ADDENDUM NUMBER: THREE

PROJECT: High School Exterior improvements – Phase 1
Johnston County Public Schools
601-A West Market Street
Smithfield, North Carolina 27577

PROJECT NO: 23028

DATE: October 30, 2023

Revisions	
ADDENDUM #3 - 10/30/2023	
Date	Project No.
09/28/23	23028
Drawn By	Sheet No.
ABG	A-A1.3
Checked By	
TDO	
Sheet Title	
NORTH JOHNSTON HIGH PHOTOS

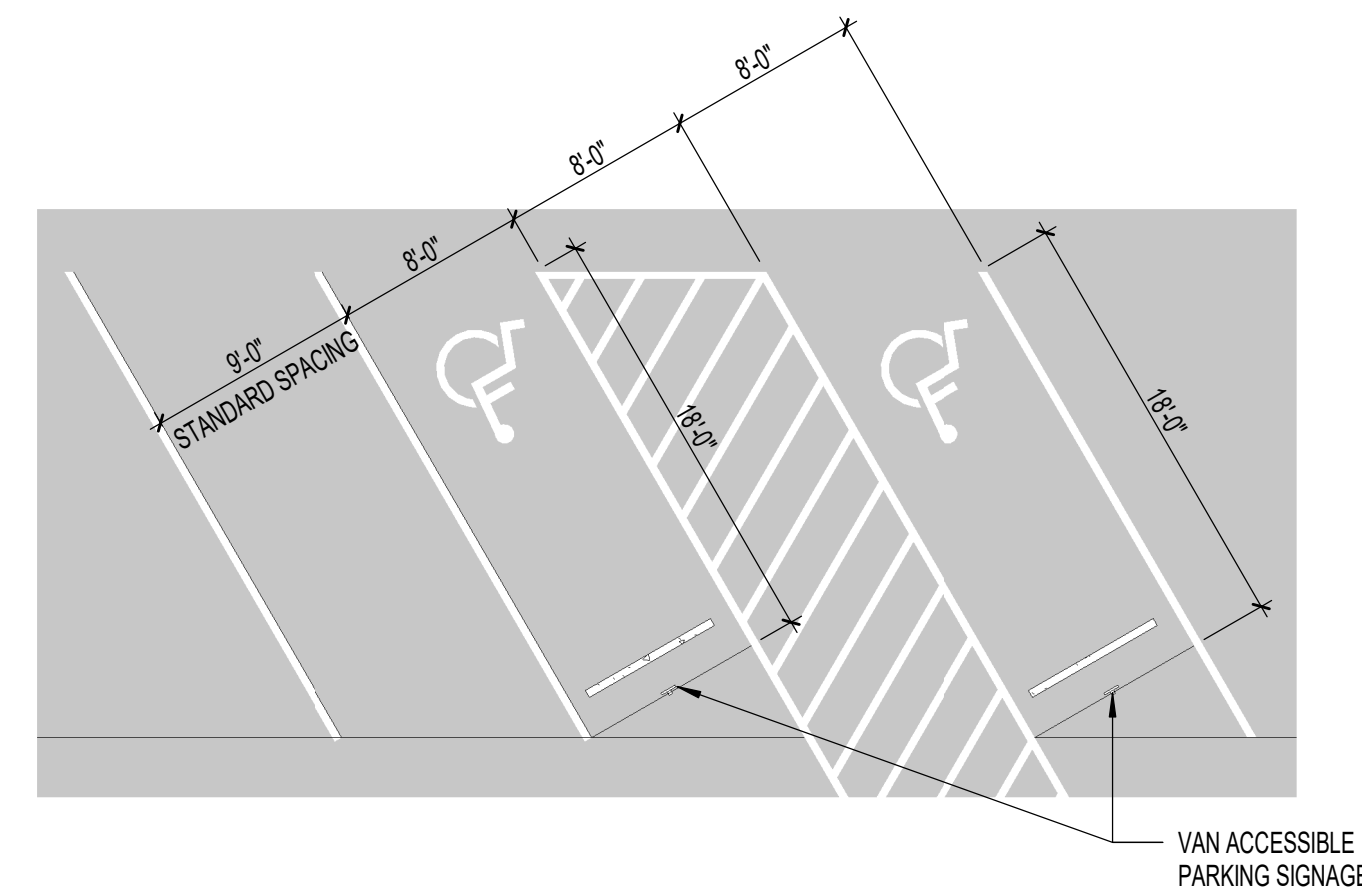
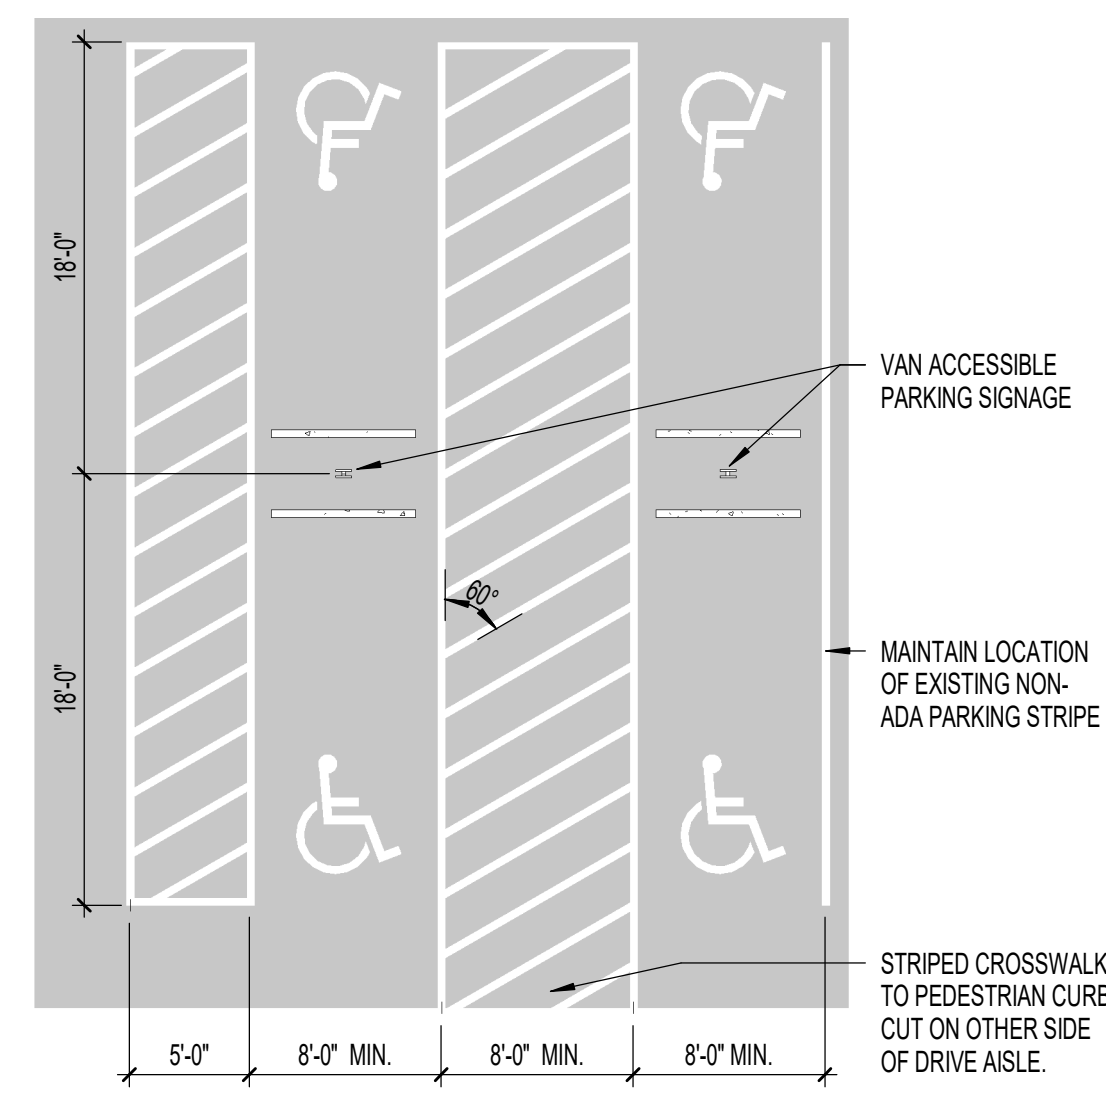
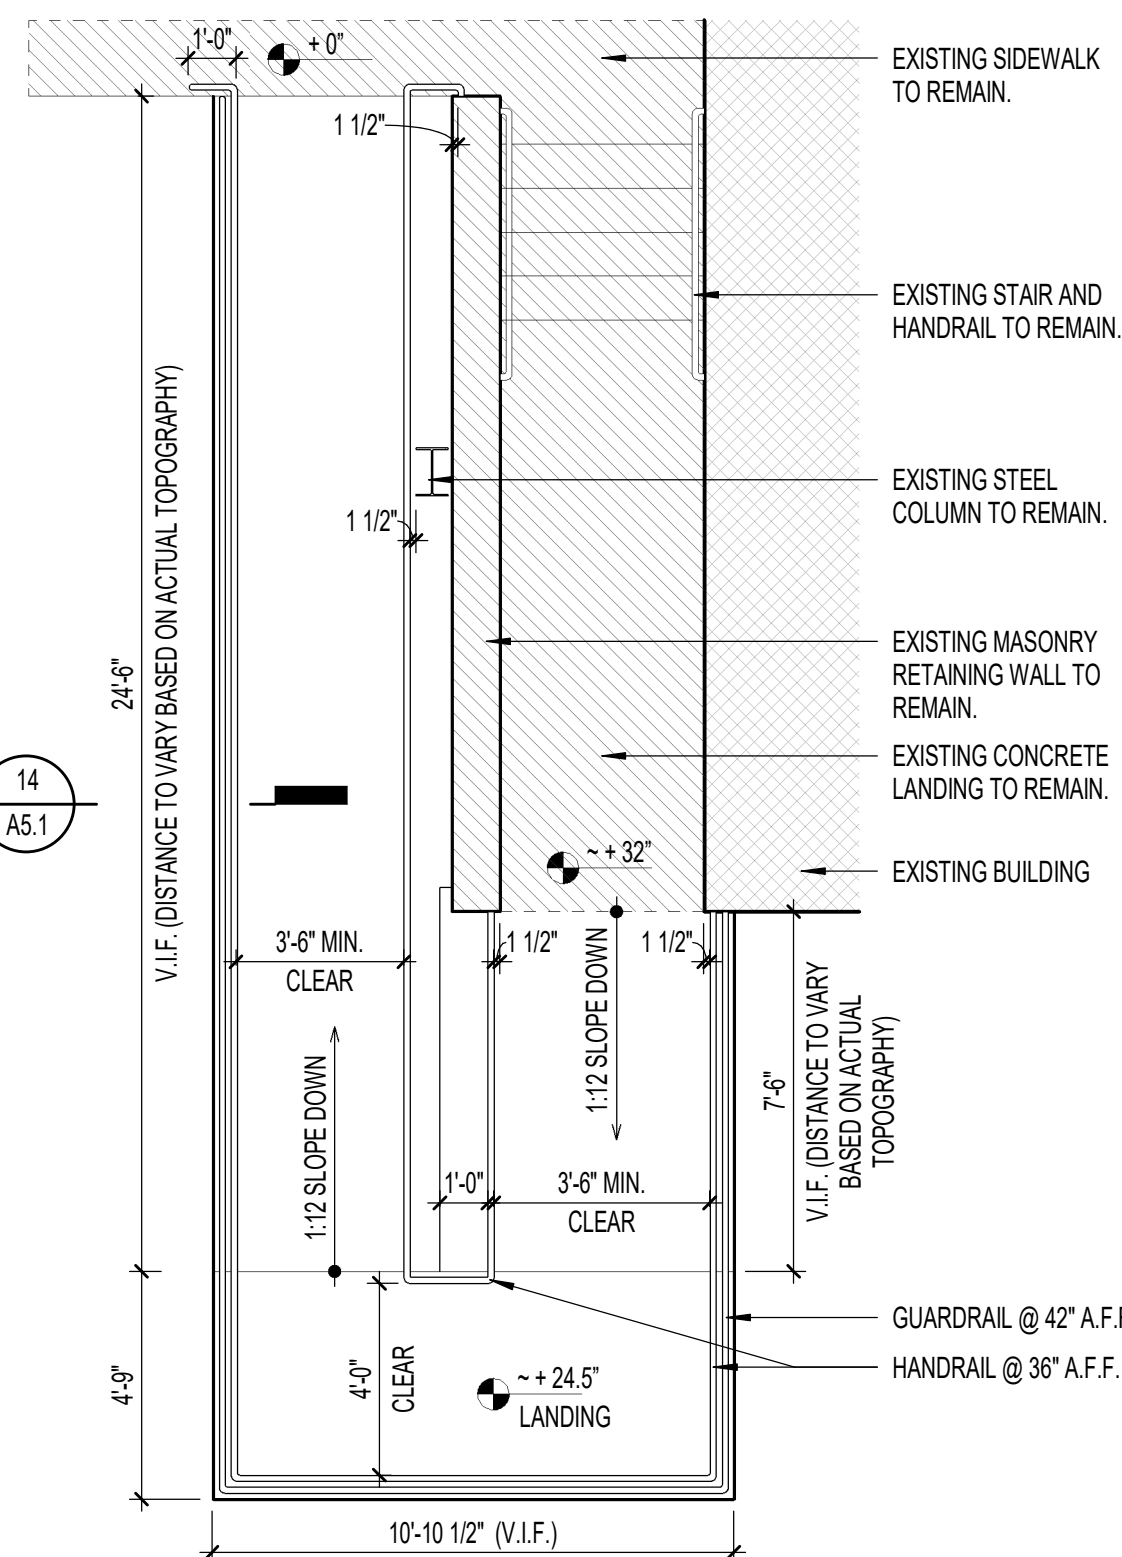
Sheets A-A1.1, A-A1.2, & A-A1.3 – North Johnston High School

Remove existing sheets in their entirety and replace with the attached sheets. Revised keynotes to reflect Bid Alternate G-1: Pre-manufactured Aluminum Ramps.

3. PROVIDE NEW PRE-MANUFACTURED ALUMINUM LANDINGS AND RAMPS FOR EACH MOBILE UNIT ENTRANCE. AS REQUIRED. DEMOLISH EXISTING BOARDWALK AND REPLACE WITH ACCESSIBLE BOARDWALK WALKWAY AND A 5 FT. x 5 FT. LANDING AT THE BASE OF EACH RAMP WITH A FINISHES ELEVATION OF 30 INCHES (MAX.) BELOW EACH RESPECTIVE MOBILE UNIT DOOR THRESHOLD. BOARDWALK IS TO BE BUILT OUT OF P.T. LUMBER OF SIMILAR SIZE AND TYPE AS EXISTING. PROVIDE A NON-SLIP SURFACE AS REQUIRED. PROVIDE CONCRETE PAD FOR NEW LANDINGS AND RAMPS. CONTRACTOR TO VERIFY SIZE OF CONCRETE PAD NEEDED IN FIELD. SEE ALTERNATE G-1 FOR MORE INFORMATION.

Date	Project No.
09/28/23	23028
Drawn By	Sheet No.
ABG	
Checked By	C-A1.2
AWC	
Sheet Title	
SMITHFIELD-SELMA HIGH PHOTOS

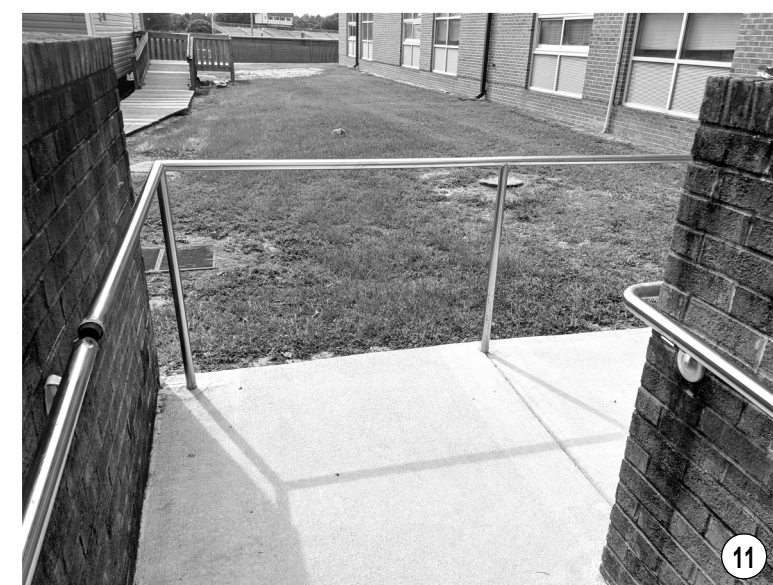
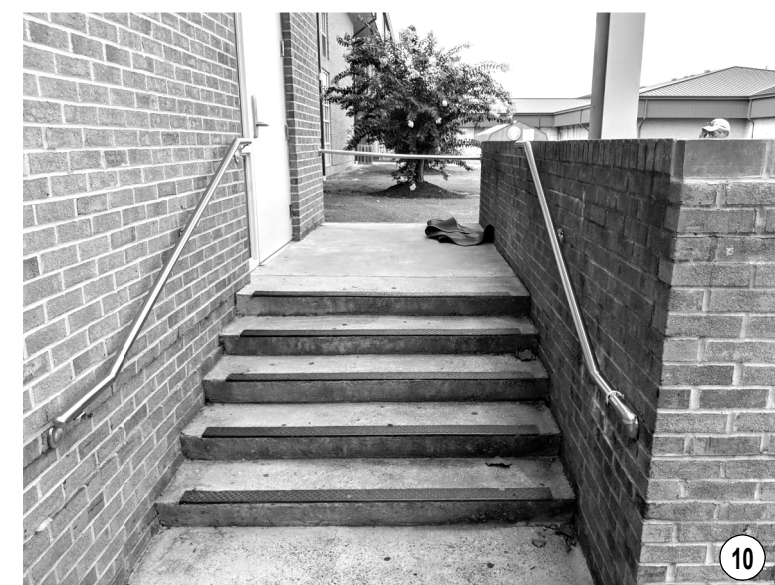
Sheets C-A1.1 & C-A1.2 – Smithfield Selma High School

Remove existing sheets in their entirety and replace with the attached sheets. Revised keynotes to reflect Bid Alternate G-1: Pre-manufactured Aluminum Ramps.

12. PROVIDE NEW PRE-MANUFACTURED ALUMINUM LANDINGS AND RAMP FOR EACH MOBILE UNIT ENTRANCE AS REQUIRED. DEMOLISH EXISTING BOARDWALK AND REPLACE WITH ACCESSIBLE BOARDWALK WALKWAY AND A 5 FT. x 5 FT. LANDING AT THE BASE OF EACH RAMP WITH A FINISHES ELEVATION OF 30 INCHES (MAX.) BELOW EACH RESPECTIVE MOBILE UNIT DOOR THRESHOLD. BOARDWALK IS TO BE BUILT OUT OF P.T. LUMBER OF SIMILAR SIZE AND TYPE AS EXISTING. PROVIDE A NON-SLIP SURFACE AS REQUIRED. PROVIDE CONCRETE PAD FOR NEW LANDINGS AND RAMP. CONTRACTOR TO VERIFY SIZE OF CONCRETE PAD NEEDED IN FIELD. SEE ALTERNATE G-1 FOR MORE INFORMATION.

Revisions	
ADDENDUM #3 - 10/30/2023	
Date	Project No.
09/28/23	23028
Drawn By	Sheet No.
ABG	D-A1.1
Checked By	
AWC	
Sheet Title	
SOUTH CAMPUS HIGH/MIDDLE SITE

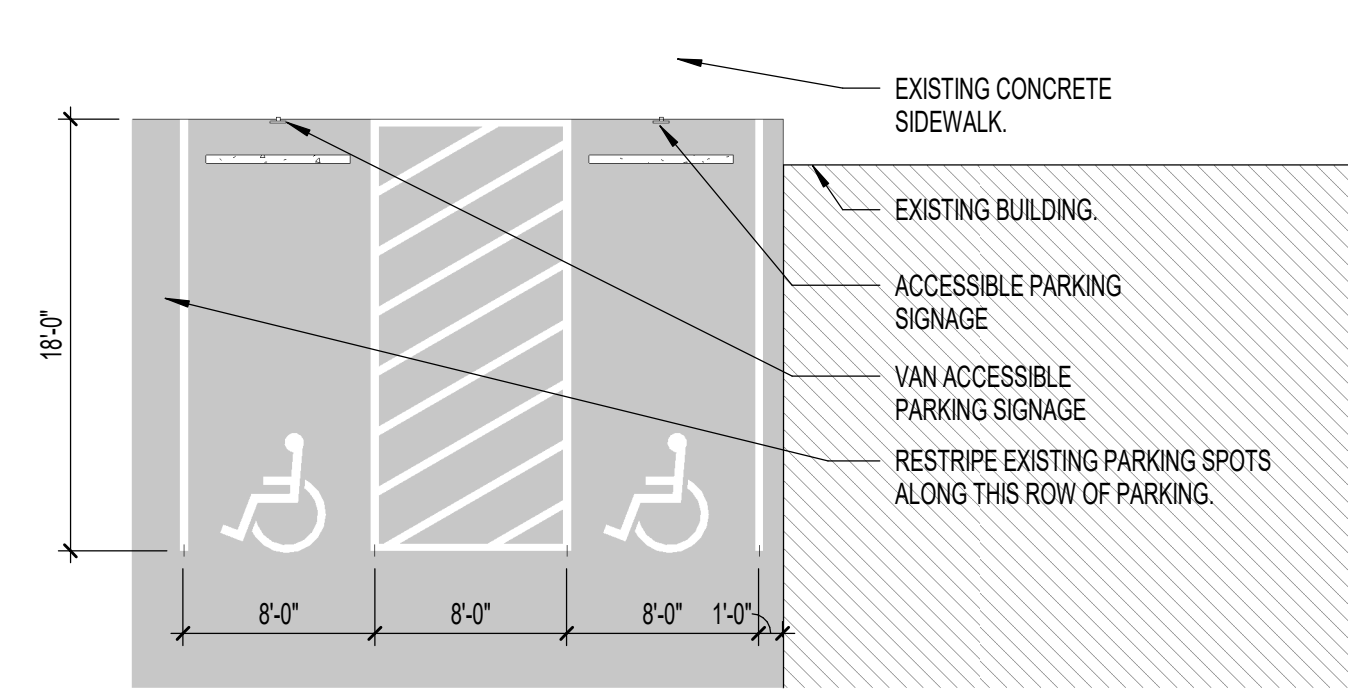
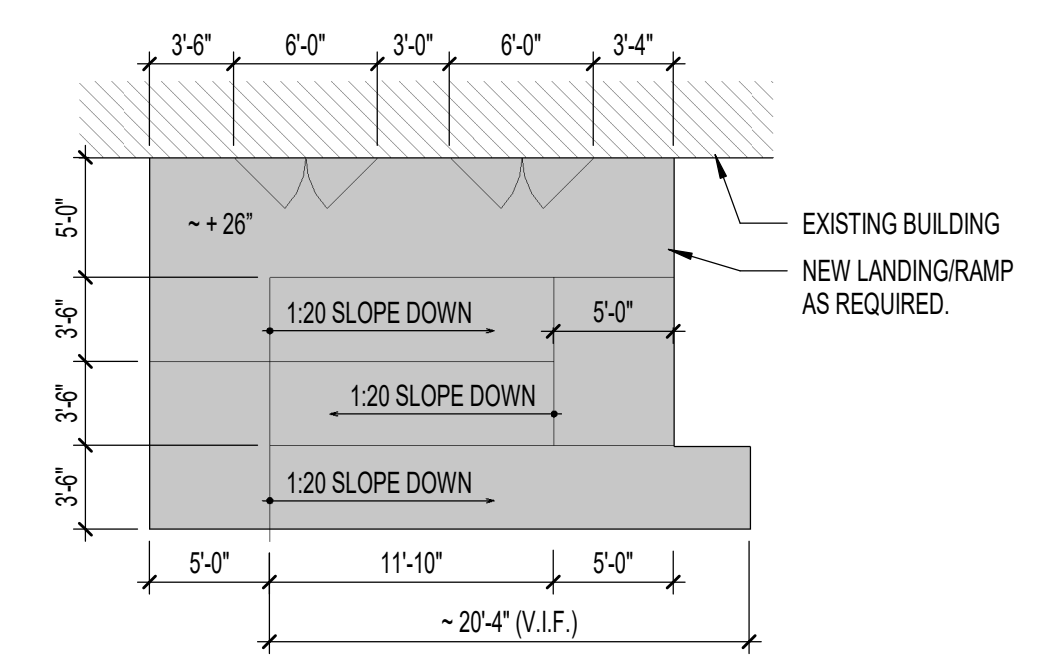
Sheets D-A1.1 & D-A1.2 – Innovation Academy at South Campus

Remove existing sheets in their entirety and replace with the attached sheets. Revised keynotes to reflect Bid Alternate G-1: Pre-manufactured Aluminum Ramps.

4. PROVIDE NEW PRE-MANUFACTURED ALUMINUM LANDINGS AND RAMPS FOR EACH MOBILE UNIT ENTRANCE (4) AS REQUIRED. DEMOLISH EXISTING BOARDWALK AND REPLACE WITH ACCESSIBLE BOARDWALK WALKWAY AND A 5 FT. x 5 FT. LANDING AT THE BASE OF EACH RAMP WITH A FINISHES ELEVATION OF 30 INCHES (MAX.) BELOW EACH RESPECTIVE MOBILE UNIT DOOR THRESHOLD. BOARDWALK IS TO BE BUILT OUT OF P.T. LUMBER OF SIMILAR SIZE AND TYPE AS EXISTING. PROVIDE A NON-SLIP SURFACE AS REQUIRED. PROVIDE CONCRETE PAD FOR NEW LANDINGS AND RAMPS. CONTRACTOR TO VERIFY SIZE OF CONCRETE PAD NEEDED IN FIELD. SEE ALTERNATE G-1 FOR MORE INFORMATION.
